Re: Docket No. 50-271 - Extended Power Uprate at Vermont Yankee Nuclear
Power Station

Please find enclosed for filing an original and two copies of the Vermont Department of Public Service Notice of Intention to Participate and Petition to Intervene with Exhibits, Affidavit of William K. Sherman, Notice of Appearance from Sarah Hofmann and Anthony Z. Roisman, and Certificates of Service.

**Docket No. 50-271
(Extended Power Uprate)**

Figure 4.4-1

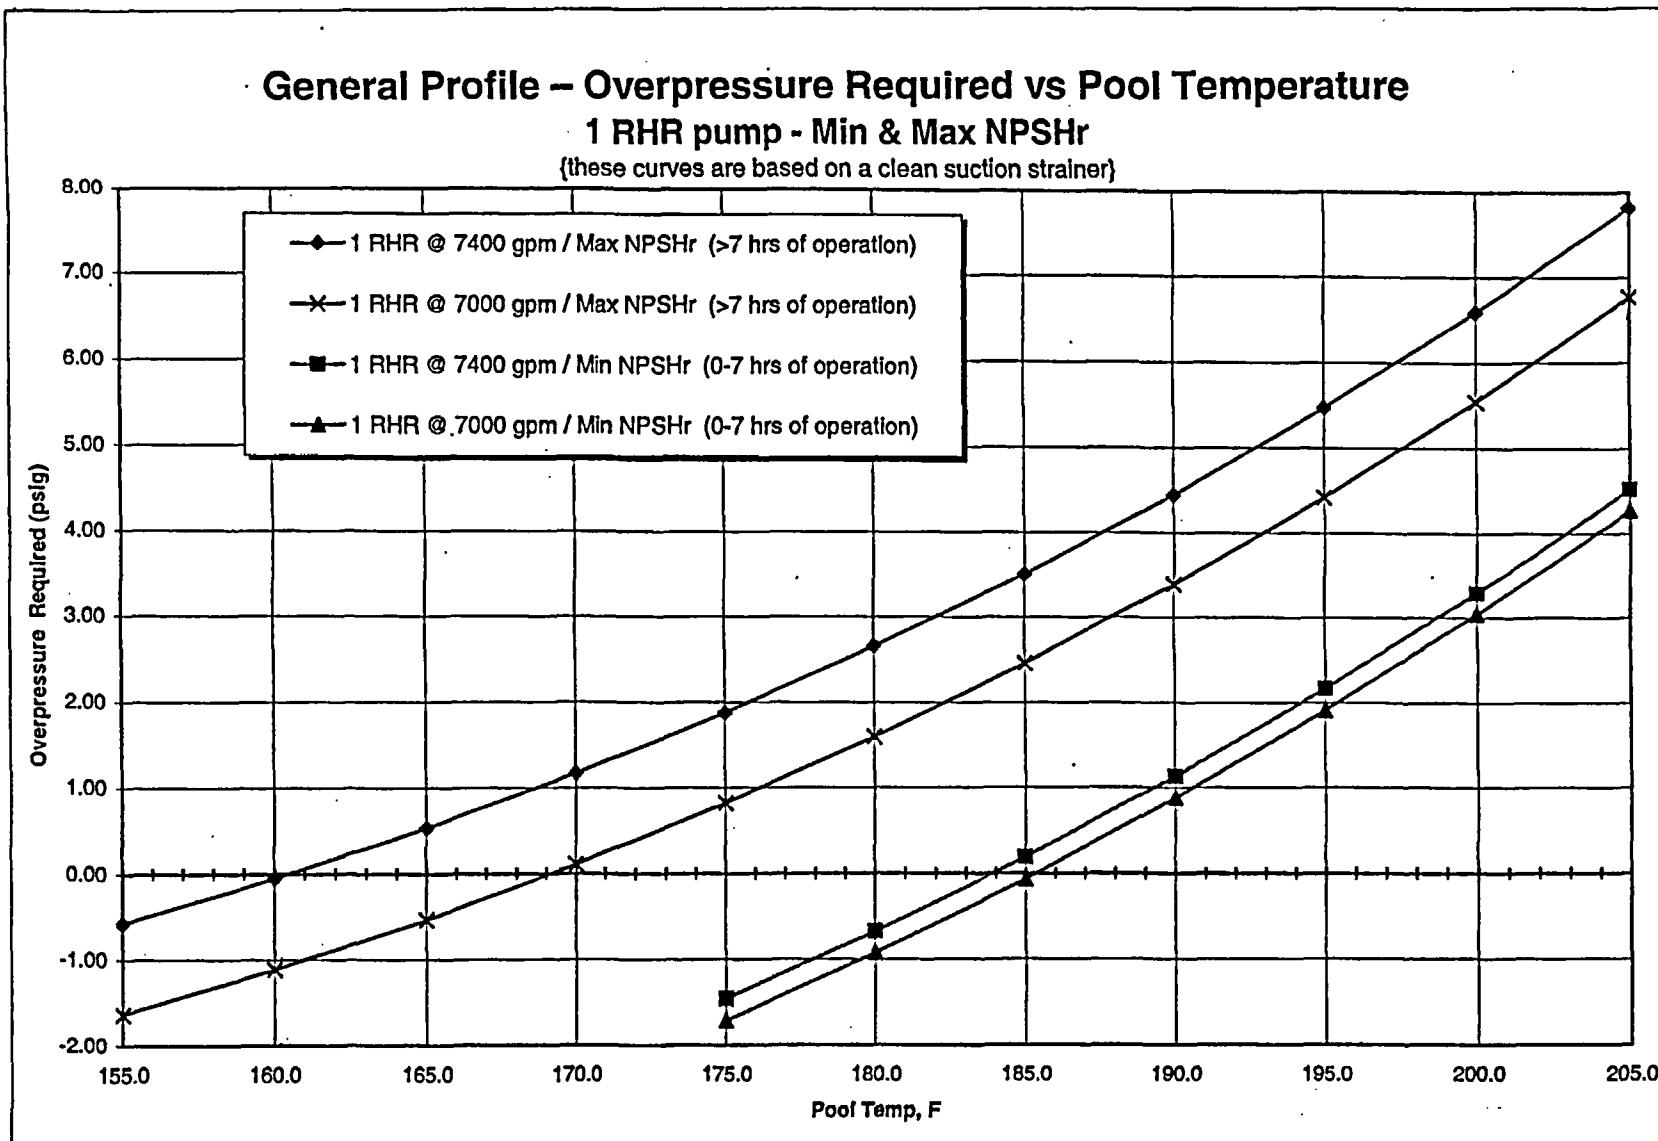
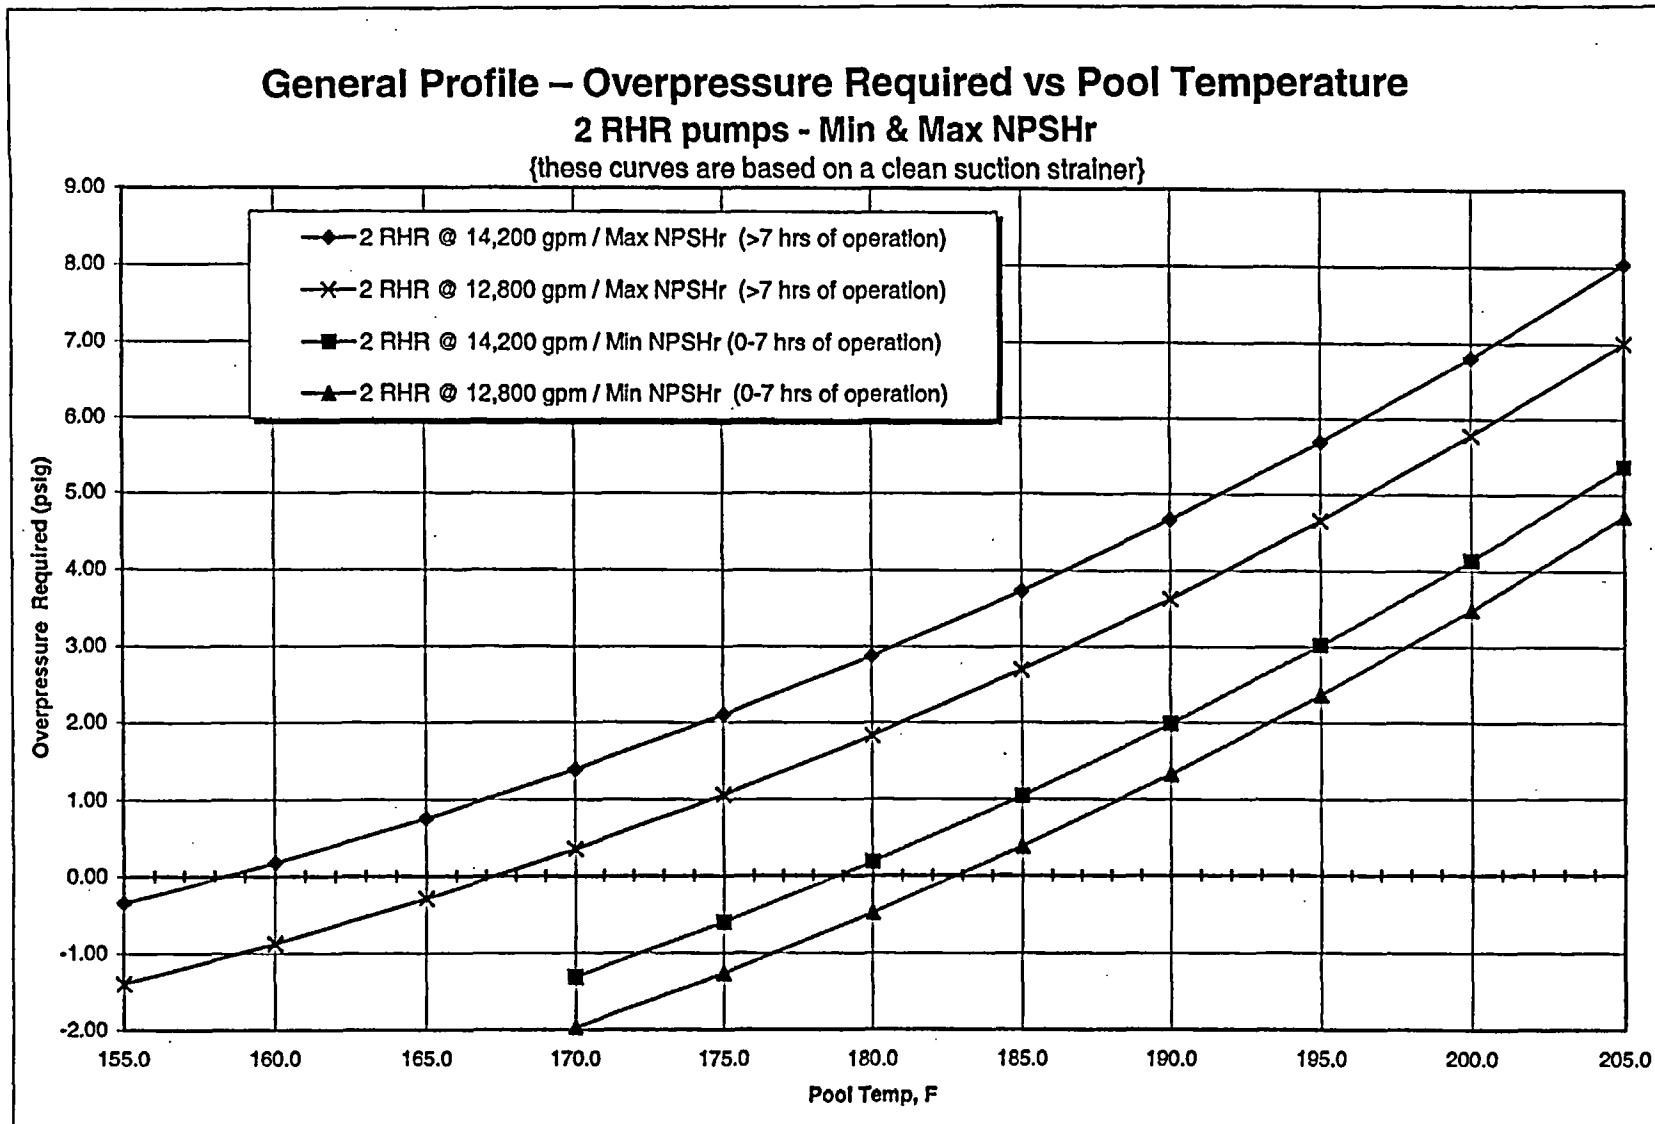
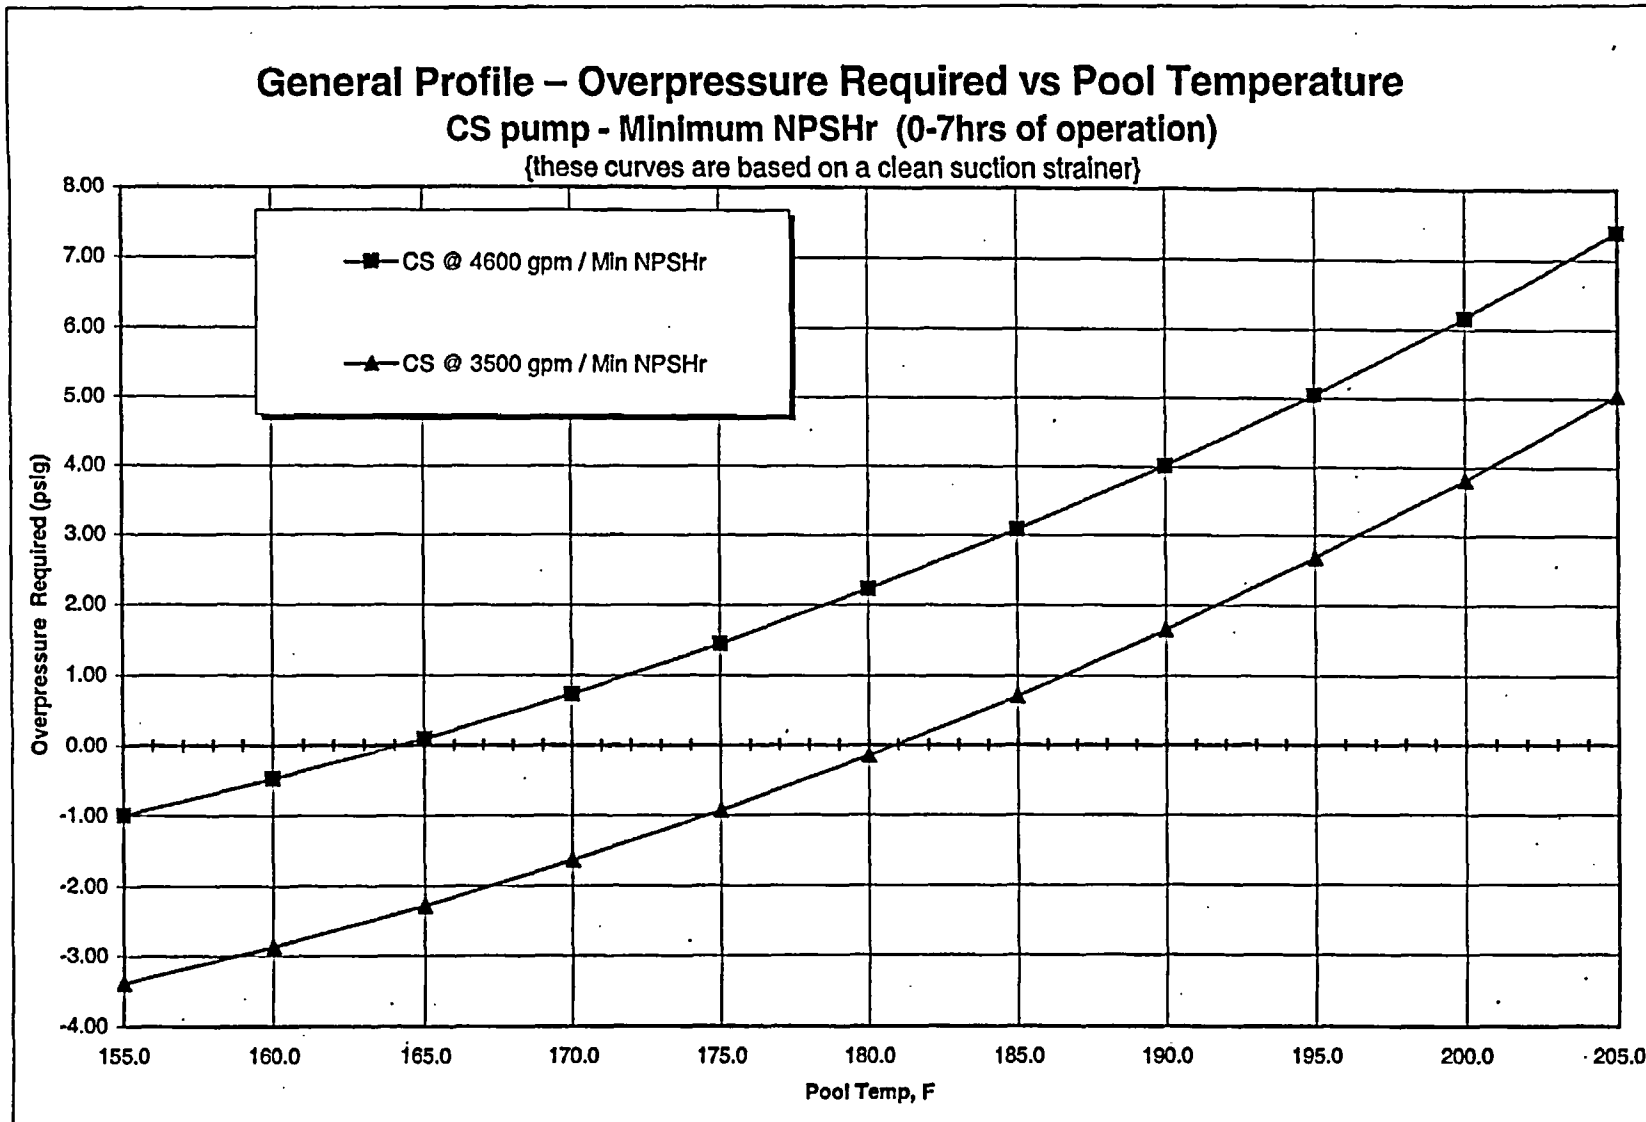
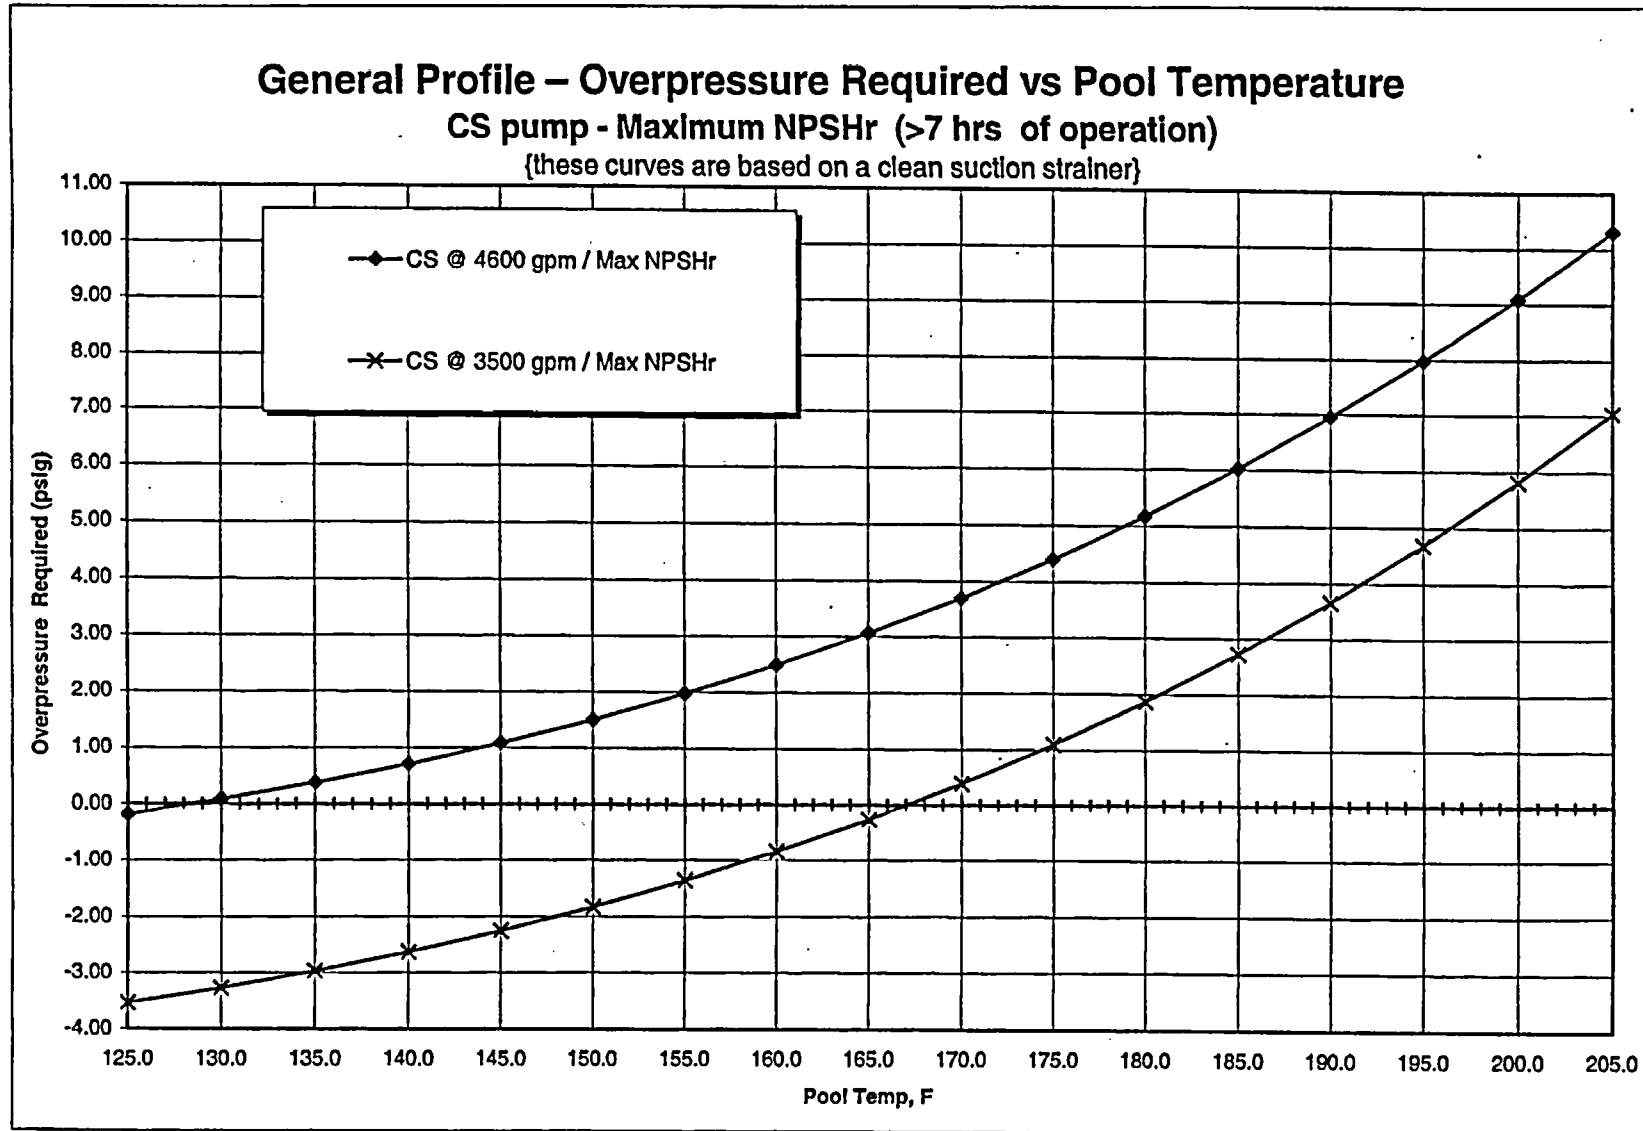
1866	VYC-0808	Bruce Slifer	Page 20, Section 5.5, should not have 4 different Figure 4s. Either list sequentially, or use 4.4.1, 4.4.2, etc.	Figures are renumbered 4.4-1 thru 4.4-4	Resolution accepted. B. Slifer 8/12/03
1867	VYC-0808	Bruce Slifer	Page 20, Section 6.0, VYC-1628 is superseded by the GE analysis, therefore revise section accordingly.	As agreed to by tel-con on 8/7/03, existing notation that VYC-1628 may be superseded by GE EPU Analysis is adequate. No change required.	Resolution accepted. B. Slifer 8/12/03
1868	VYC-0808	Bruce Slifer	Page 20, provide source of reference to VYDC-2003-008.	As confirmed by email dated 8/11/03, VYDC-2003-008 is correct. No change required.	Resolution accepted. B. Slifer 8/12/03
